3.0 Masterplan

3.4 Design Evolution

Design workshops with LBI Officers

Key changes in response to comments

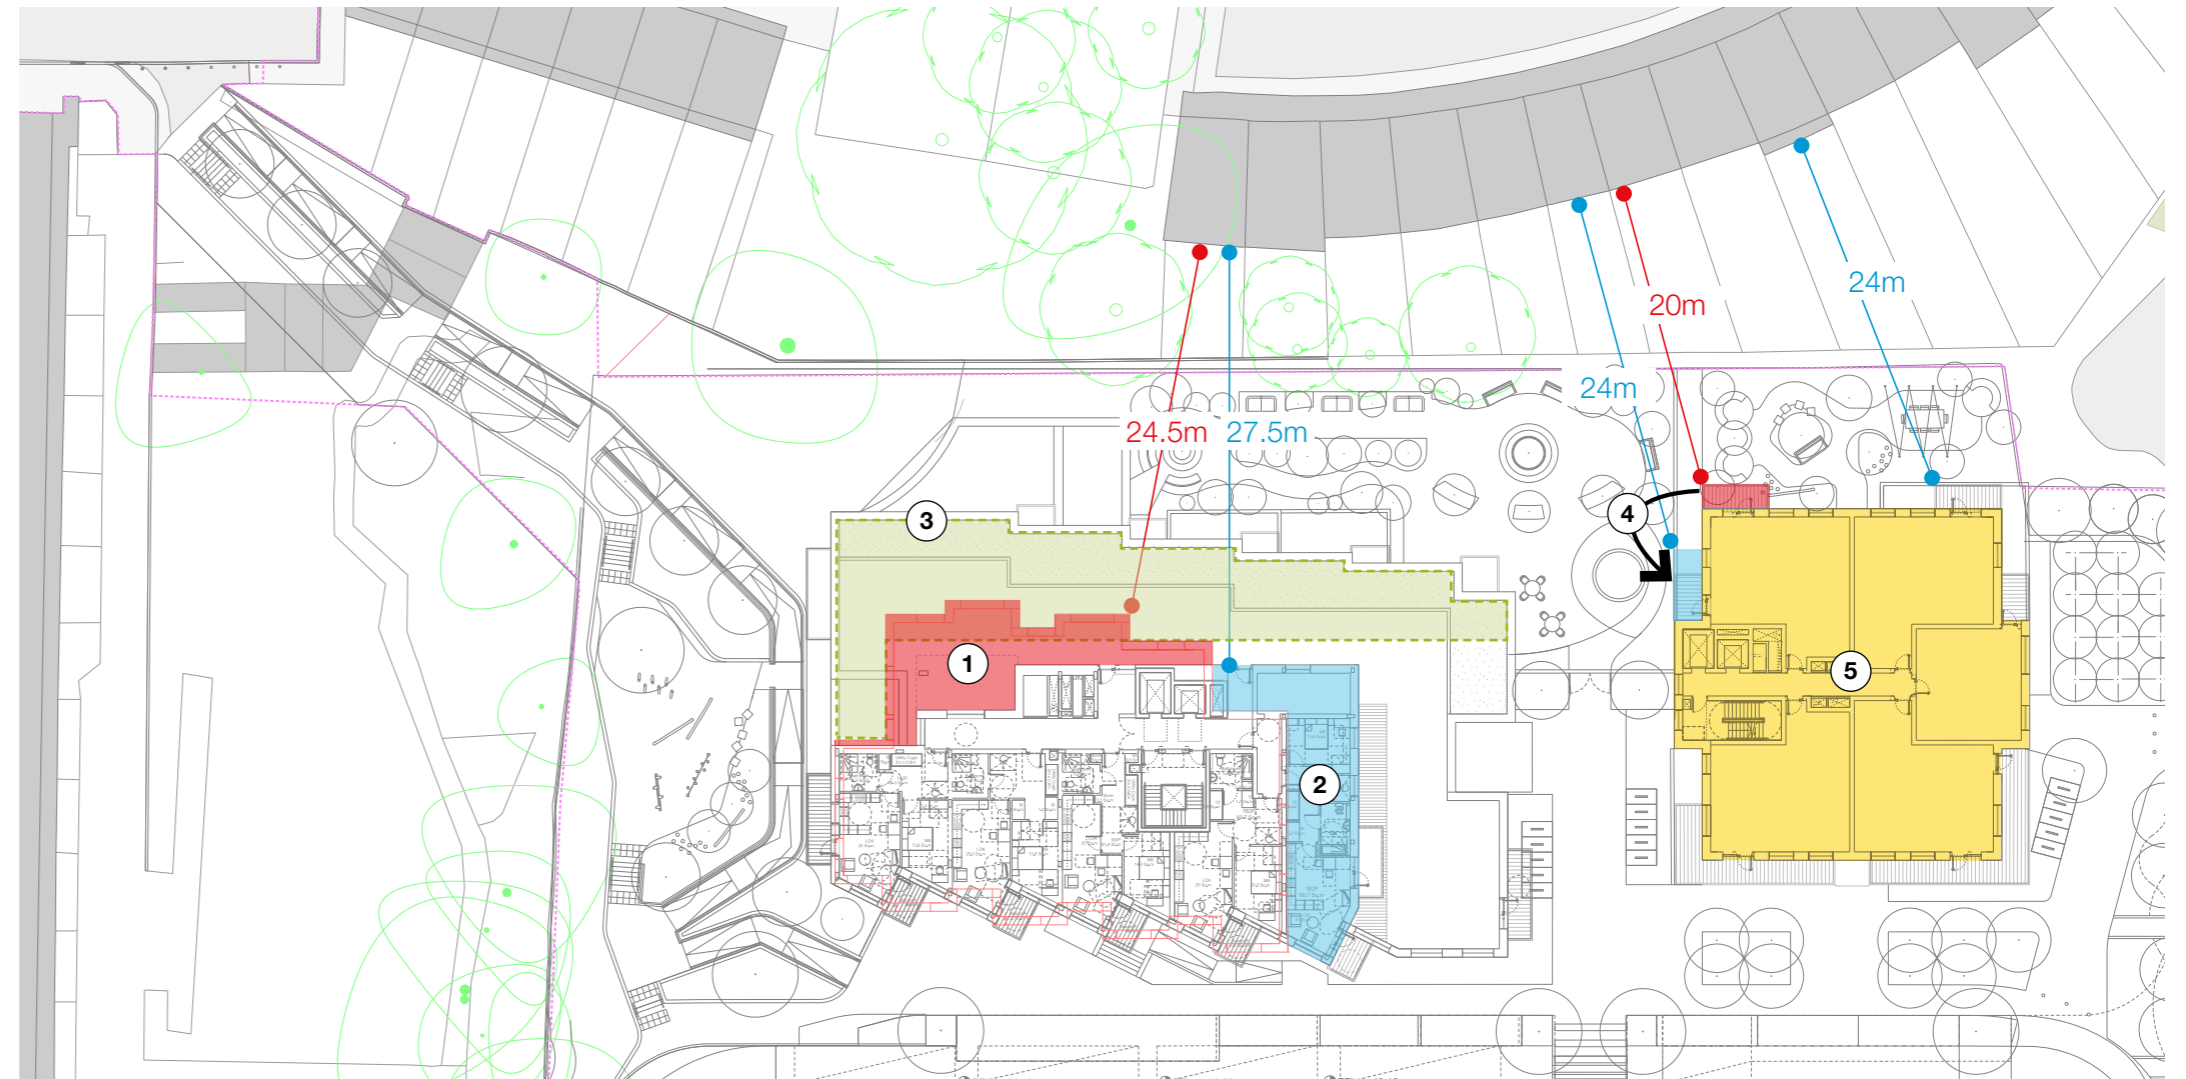
The following illustrates the changes in response to the comments received in the July 21 consultation. Penderyn Way neighbours raised concern over the proximity and overlooking. While the proposal exceeds policy requirements, we propose the following changes to respond to comments. Essentially the mass has been repositioned to sit further away, overall heights reduced, balconies moved and the terrace reduced.

- ① Red area illustrates the plan as consulted upon in July 2021.
- ② Blue area illustrates the mass repositioned 3m further away from the neighbours.
- ③ Green area illustrates the roof terraces as proposed in the July '21 consultation which has now been reduced to respond to concerns raised by Penderyn way residents.
- ④ The balcony in red is removed and the balcony highlighted in blue is extended to provide sufficient private amenity space. This reduces overlooking and improves privacy as well as extending the distance between balconies and windows to the dimensions noted.
- ⑤ The overall height of the building highlighted in yellow is reduced by 950mm.
